Technical Basis for Comments:  
New Source Performance Standards  
for Stationary Combustion Turbines and Gas Turbines

American Public Power Association  
Midwest Ozone Group  
Power Generators Air Coalition

April 14, 2025

Figure 2-1. Combustion Turbine Population Distribution, by Nameplate Capacity

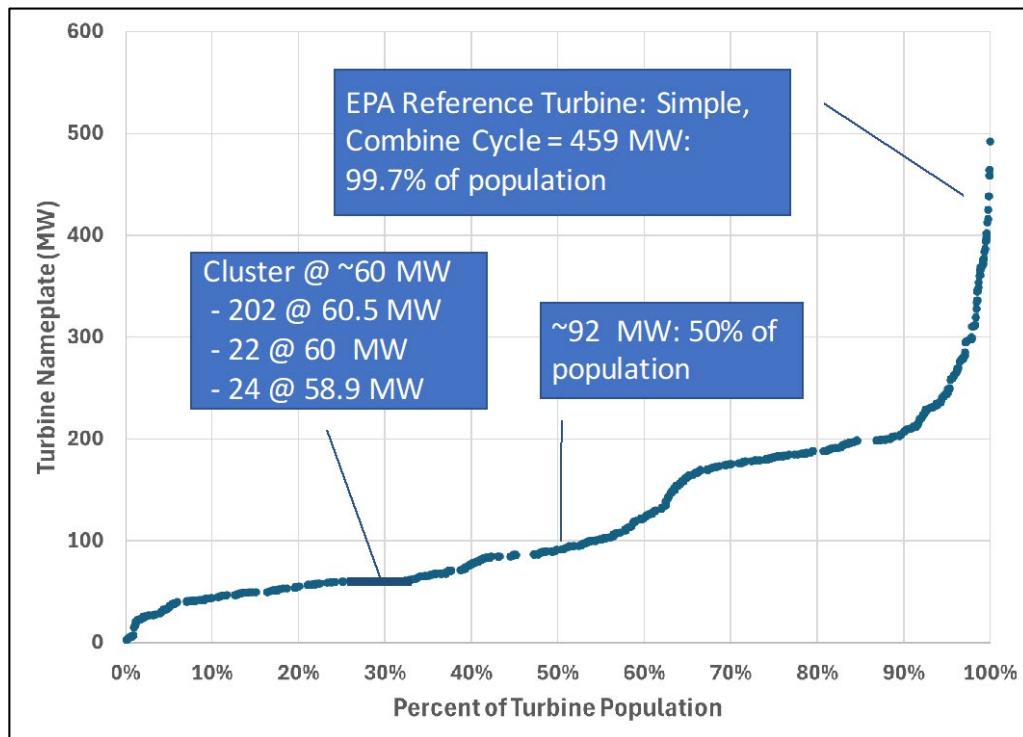
Figure 2-1 presents the population distribution of existing gas turbines of 25 megawatts (MW) or greater, according to nameplate generating capacity (in MW).<sup>9</sup> A total of approximately 2,850 units exceed 25 MW. Figure 2-1 shows that the mid-point of the population corresponds to a generating capacity of 92 MW, roughly around EPA’s designation of 850 MMBtu/h as the threshold for large combustion turbines. Figure 2-1 also reveals a cluster of approximately 250 units of about 60 MW capacity, reflecting popular aeroderivative designs. The figure also shows 90% of the combustion turbine population generates less than 200 MW; with the upper 4% of the population capable of 300 to 475 MW of capacity.

Figure 4-1. Operating Duty for an Ocotillo Simple Cycle Unit

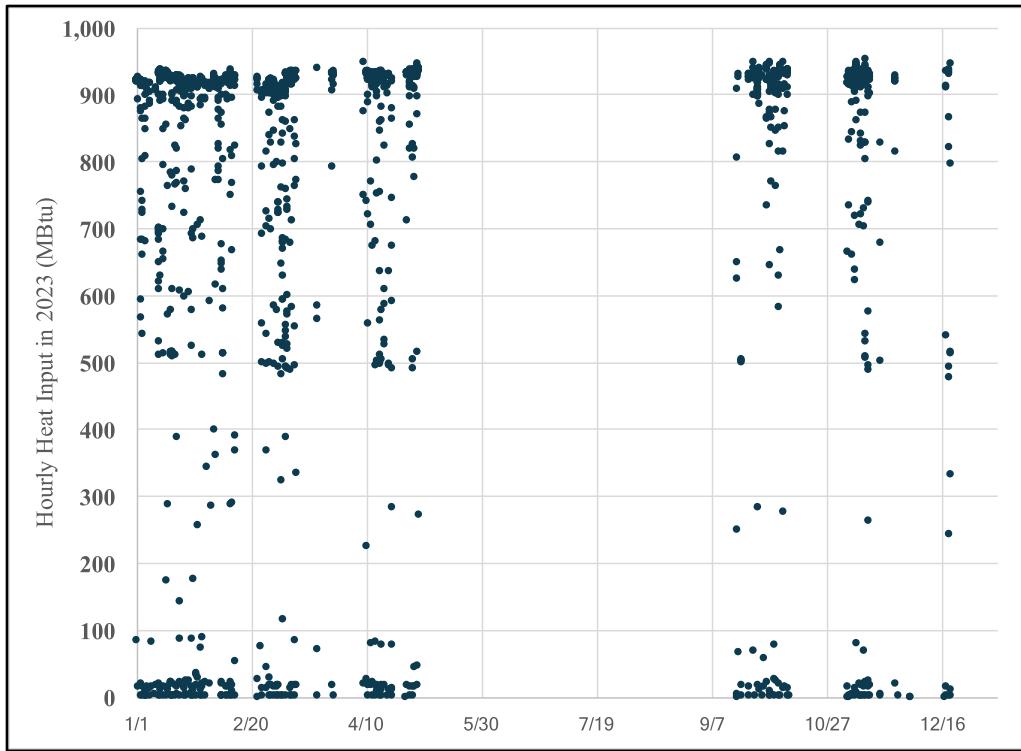
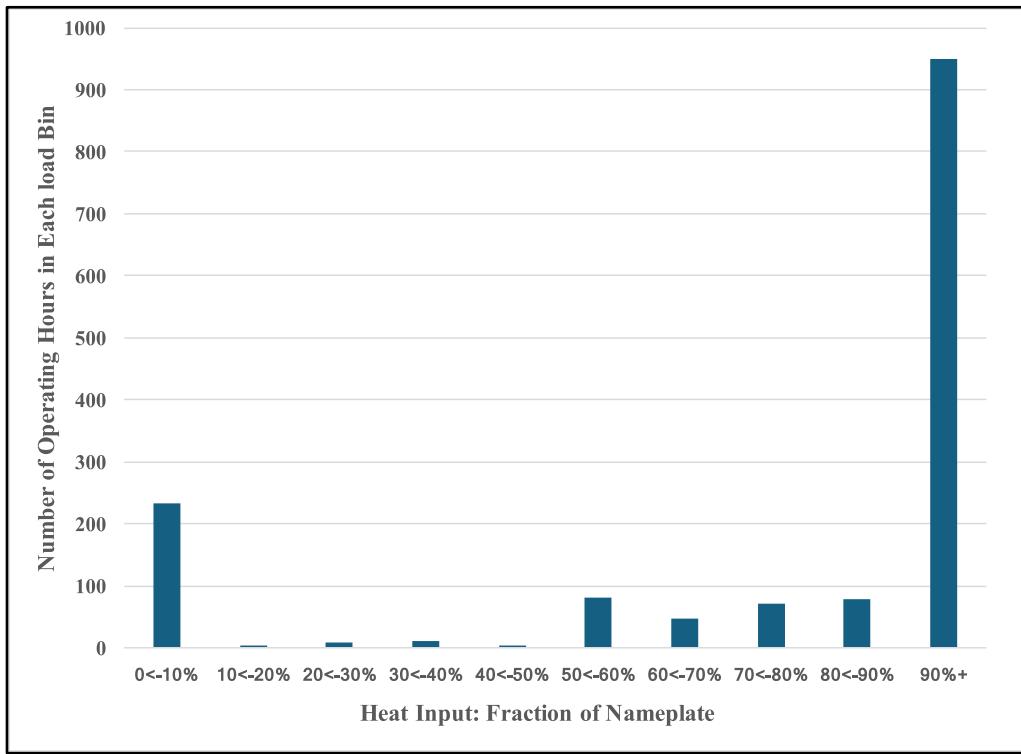
Figure 4-1 presents the duty cycle describing heat throughput over the 12 months of 2023 and shows the unit rapidly transits from startup to high load. The operating hours are shown to cluster around extremely low and high load.

Figure 4-2 presents the same data but with more clarity documenting that most operation is at less than 10% nameplate capacity, which is essentially startup, or between 90-100% of nameplate heat throughput.

The annual capacity factor for the unit as shown is approximately 18%, implying the unit operates for about 1,600 hours annually. Most units operating in simple cycle are described by a load profile as shown in Figures 4-1 and 4-2.

Figure 4-3. FGD Equipped Units: Role of 3-Year Capacity Factor

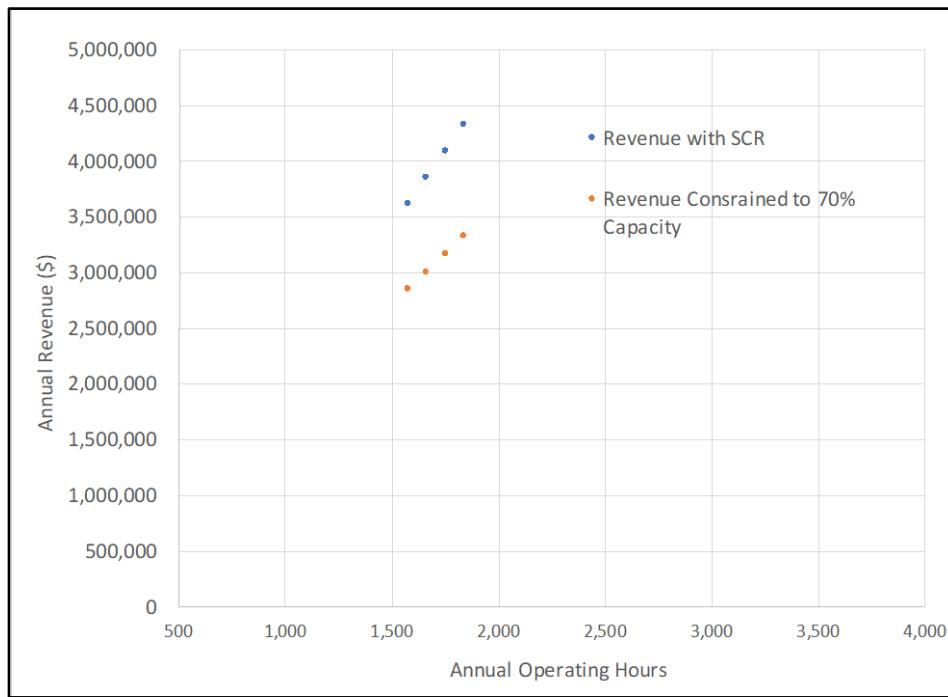
Figure 4-3 shows net revenue for the interval of 1,600 – 1,800 operating hours for the unit without SCR, intentionally limited to part load, compared to revenue for an SCR-equipped unit. The calculation for net revenue for the SCR-equipped unit includes the annual capital charge and operating cost for the SCR process<sup>22</sup> and the benefit of lower fuel cost due to lower heat rate. Even with higher cost to pay for SCR, this case derives an additional \$0.80M annually. An owner intentionally operating a simple cycle unit of this type without SCR will forgo this additional revenue. The contrast would be more severe for larger and combined cycle units.

As noted in the preceding section, there is no economic benefit to intentionally restrict operation to below the high load capacity. The economic penalty is not a hypothetical calculation, as shown in Figure 4-3. The cost penalty for such actions is substantial, as shown in Figure 4-3.

Figure 4-4. Operating Hours Exceeding 70% Load: Medium, Large Combined Cycle Units

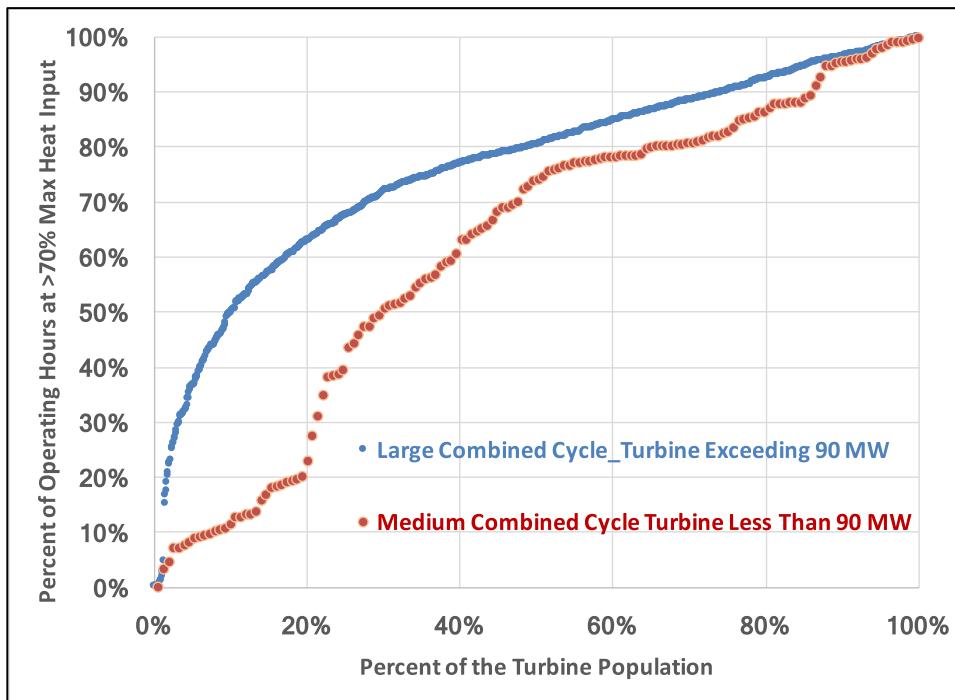
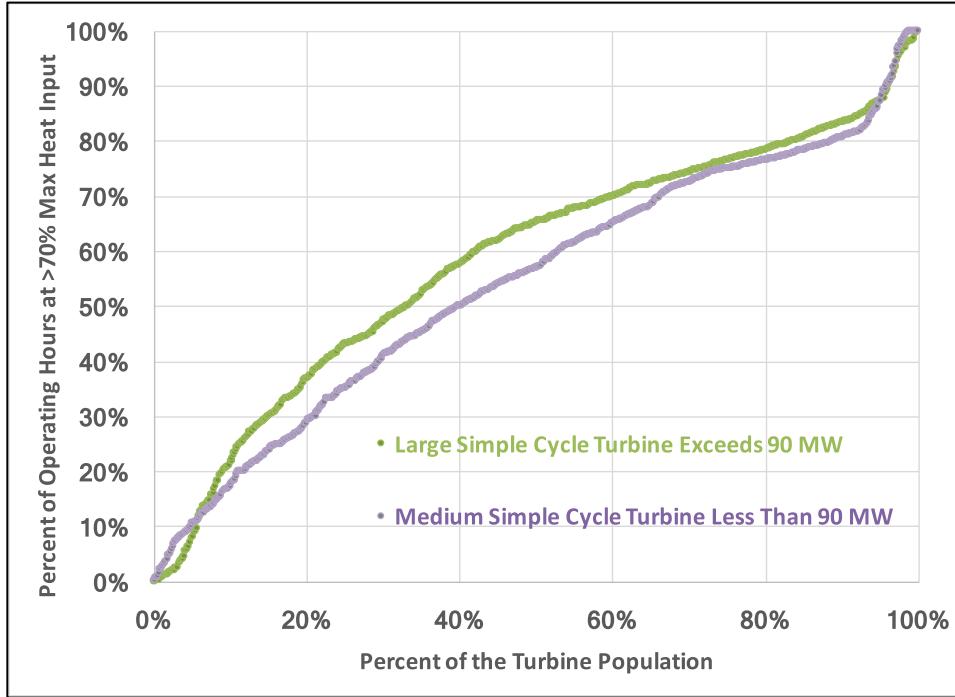
Figures 4-4 and 4-5 show that, currently and in the past, some units operate at part load more than others. This is not the result of a perverse incentive that EPA suggests (currently, the most stringent high load NOx standard under KKKK is 15 ppm). Rather, if a unit is currently spending more time than another unit at part load, it is because the market demands it.

Figures 4-4 presents the fraction of operating time (vertical axis) at high load for large and medium combined cycle units, as a function of the percent of turbine population. Figure 4-4 shows units at the mid-point of the population generally expend 80% of operating time at high load, demonstrating a preference for operating at conditions requiring SCR NOx controls.

Figure 6-1. Ductwork Between Heat Recovery Steam Generator Inlet, First Tube Bundle

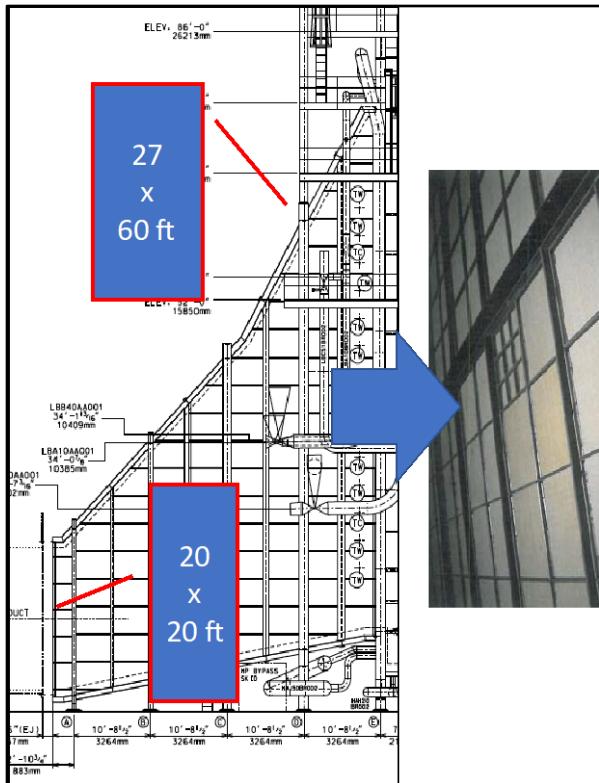
Figures 6-1 presents sectional drawings of the transition duct for combined cycle SCR applications. Figure 6-1 shows ductwork expands by approximately a factor of three, from a nominal 20 x 20-foot cross section at the combustion turbine exit, to a 27 x 60-foot cross-section at the inlet of the first heat recovery steam generator (HRSG) tube bundle.

Figure 6-2. NH<sub>3</sub>/NOx Distribution: Simple Cycle Application

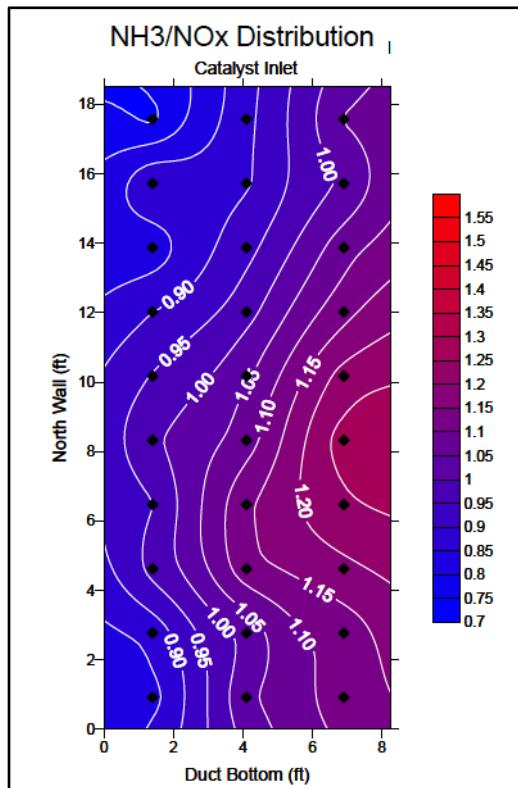
Figure 6-2 presents a typical NH<sub>3</sub>/NOx distribution “fingerprint,” characterizing the degree of uniformity of NH<sub>3</sub> and NOx across inlet ductwork of a simple cycle SCR reactor.<sup>30</sup> Figure 6-2 presents lines of constant NH<sub>3</sub>/NOx ratio, with the value of “1.0” (or unity) reflecting the desired outcome of perfectly mixed NH<sub>3</sub> in the chemically correct stoichiometric proportion. The lines of constant NH<sub>3</sub>/NOx stoichiometry less than unity reflect where NOx removal will be compromised; while those greater than unity reflect where residual NH<sub>3</sub> will be generated. The ideal NH<sub>3</sub>/NOx fingerprint features low density of lines, reflecting uniform NH<sub>3</sub>/NOx ratio.

Part-load conditions, in particular less than 50%, challenge the task of achieving good mixing of NH<sub>3</sub> in the gas flow. The extent of mixing is defined by the momentum of NH<sub>3</sub>, typically introduced within an air “jet” from the injection grid. The mixing of injected NH<sub>3</sub> is further enhanced by static mixers that impart turbulence to the gas flow. Static mixers are momentum-driven devices, thus lowering gas velocity to half or less than their value at full load compromises their effectiveness. Consequently, part load duty challenges achieving uniformity in process conditions and severely limits SCR performance.

Figure 6-4. Startup Data: GE 7FA:1 x 1 Combined Cycle Arrangement

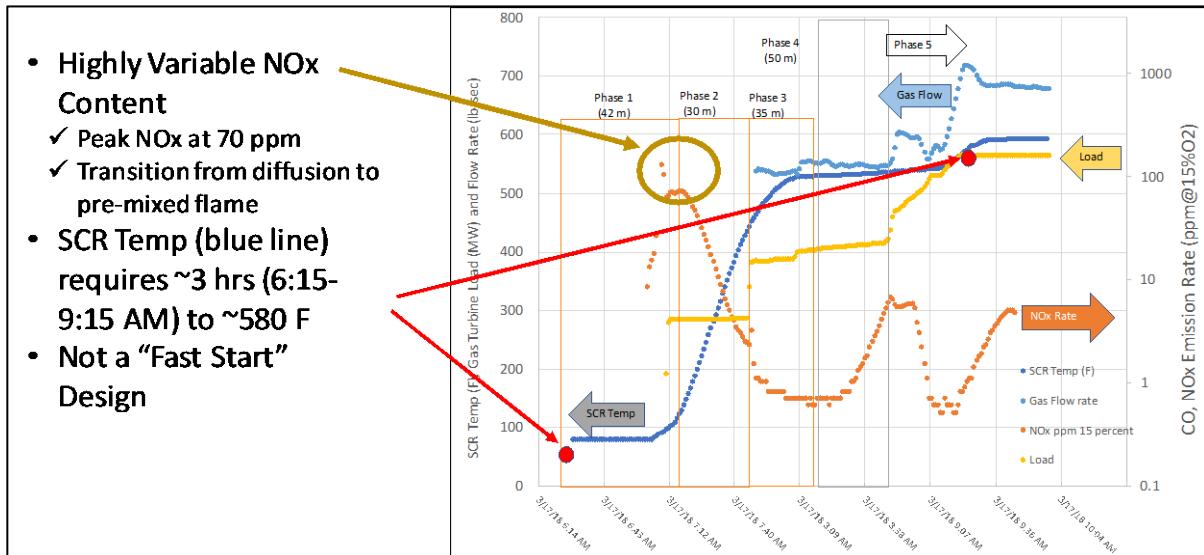
Figure 6-4 presents startup data for a GE F-Series turbine. The data presented are (a) Load (yellow), (b) Gas Flow (blue), (c) NOx content (orange), and (d) SCR temperature. Figure 6-4 demonstrates, in the case of the turbine cited, highly variable NOx content, peaking at 70 ppm for a period of approximately 30 minutes, and SCR temperature that requires almost 3 hours to achieve the minimum for ammonia reagent injection (580°F).

Consequently, several hours are required for SCR-driven NOx emission rates to be achieved. Although not a “fast-start” design, the description of process conditions in Figure 6-4 is representative for state-of-art generating units in a combined cycle.

Figure 6-5. SCR Design and Operating Parameters: Highly Transient Conditions

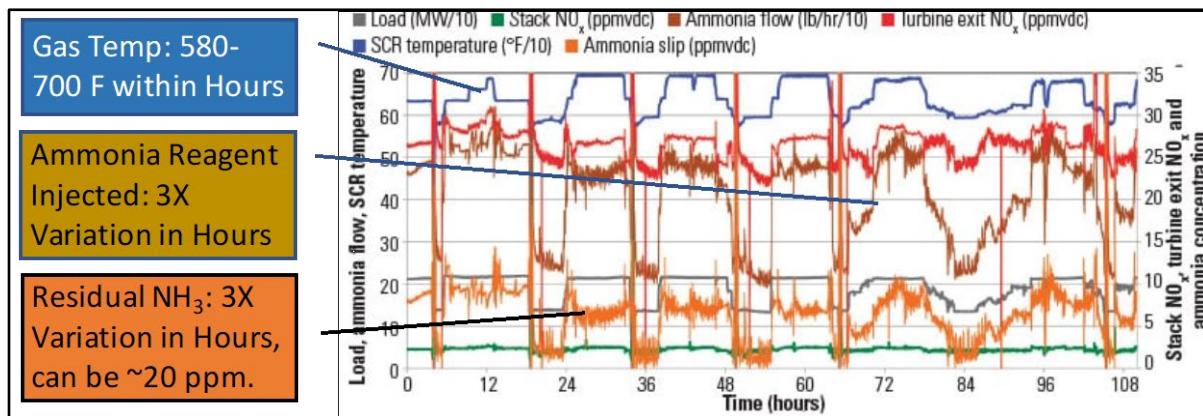
A further depiction of highly variable conditions is presented in Figure 6-5. This figure shows the variability observed over 100 hours of rapid load changes. Most notable are variations in (a) gas temperature from 580 to 700°F, within hours, (b) ammonia reagent injected, varying by a factor of 3 within hours, and (c) residual NH<sub>3</sub>, which can approach 20 ppm.

Figure 7-2. Combustion Turbines Population vs Nameplate Capacity

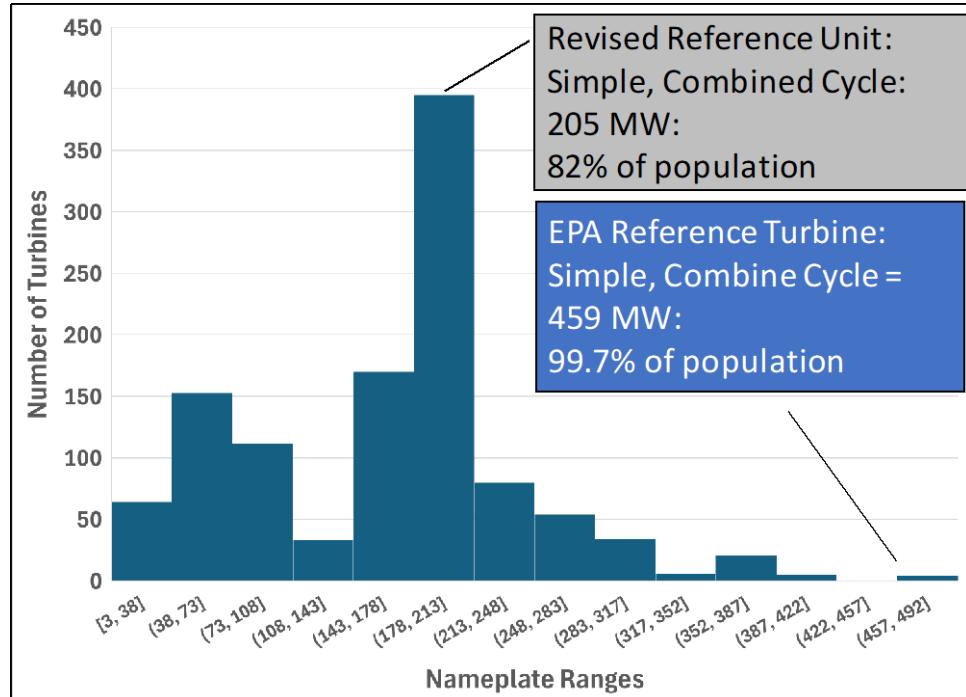
First, EPA selects a reference unit size that minimizes the cost of SCR per unit of generating capacity. Specifically, EPA selects the largest gas turbine available on the market – 4,450 MMBtu/h. Figure 7-2 shows this combustion turbine's heat throughput and capacity at the 99.7<sup>th</sup> percentile of the population. Indeed, such a large turbine corresponds to the largest H-Class turbines available on the market and likely not representative of the current H-Class turbine population. However, a capacity exceeding 82% of the present inventory, as opposed to 99.7% as projected by EPA, seems more likely. The revised reference case assumes a combustion turbine capacity of 1,780-2,130 MMBtu/h, as exhibited in Figure 7-2, and is adopted for this study.

Figure 7-3. Salt River Project Ocotillo Simple Cycle Unit Equipped with SCR

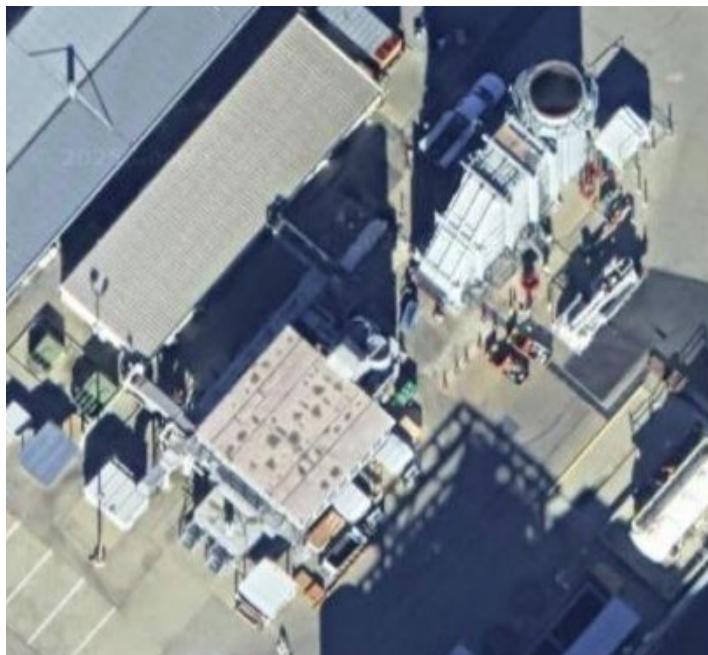
Figure 7-3 is a satellite image of a typical F-Class simple cycle combustion turbine equipped with SCR, demonstrating the space required and relative location of the SCR. Simple cycle units not initially configured for SCR usually do not have adequate “footprint” for ductwork, as the turbine exit is typically close-coupled to the stack to minimize ductwork and gas pressure drop.

The retrofit of such process equipment will require either relocating the stack or configuring the SCR reactor in a parallel duct or “sidecar” concept. Either of these adds gas pressure drop and create a tortuous path for gas flow, making it difficult to achieve a uniform gas flow distribution at the catalyst inlet. To achieve high NOx removal relocating the stack and maintaining a simple gas flow are needed. The associated costs make this unrealistic.

Figure 7-4. Sectional Drawing: HRSG Design to Accommodate SCR

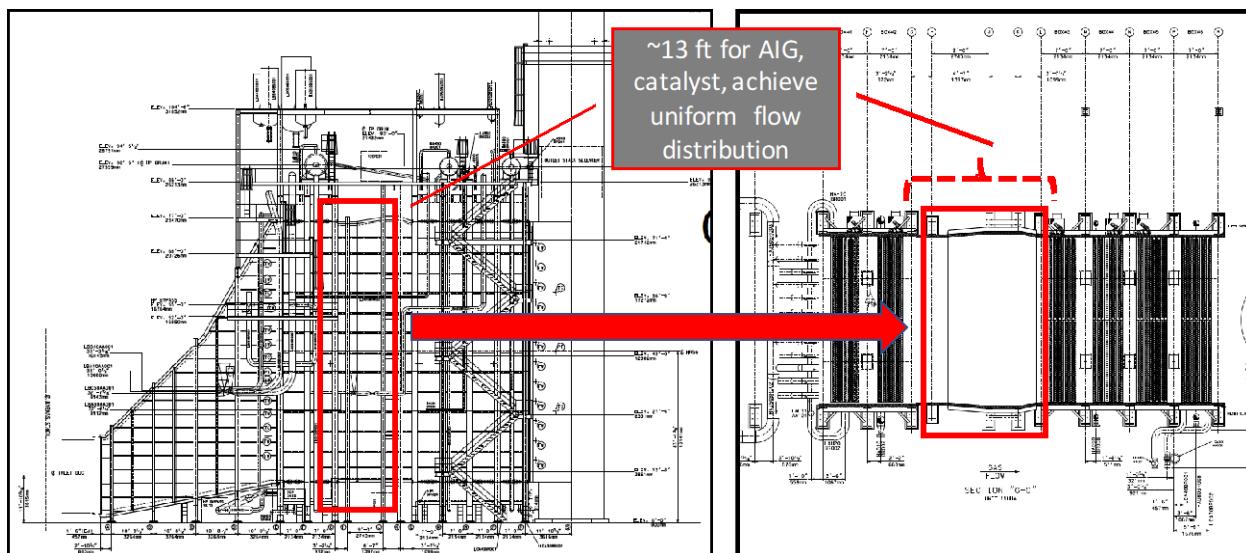
Figure 7-4 presents a schematic view of a heat recovery steam generator configured for SCR. This figure shows approximately 13 feet of process equipment is needed.

Figure 7-5. Jackson Unit: Options to Retrofit SCR

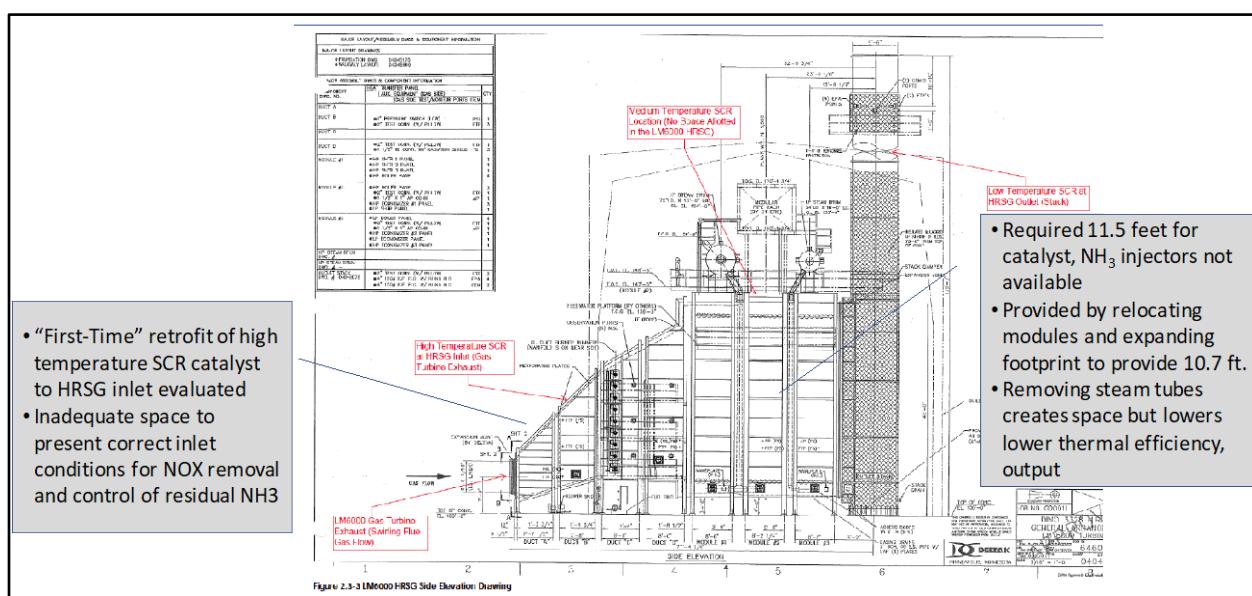
Figure 7-5 presents an engineering sectional view of the HRSG for the existing Jackson Generating Station<sup>45</sup> in Michigan. Two means were explored to retrofit SCR. First, the conventional approach of modifying the HRSG to accommodate SCR process equipment was evaluated. The SCR process design identified 11.5 feet as required, which is not feasible as the existing arrangement provides approximately 3 feet. Removing steam tubes could expand the footprint to 11 feet, but this would reduce the output and thermal efficiency of generation.

The second approach considered was to uniquely attempt to retrofit an SCR catalyst into the HRSG's expansion ductwork. This action—never attempted commercially—was abandoned due to the inability to rectify the highly turbulent gas flow into a well-behaved uniform flow pattern and inject reagent to achieve the desired mixing uniformity.

Costs were not developed for either approach as the technical feasibility was judged inadequate for a commercial venture.
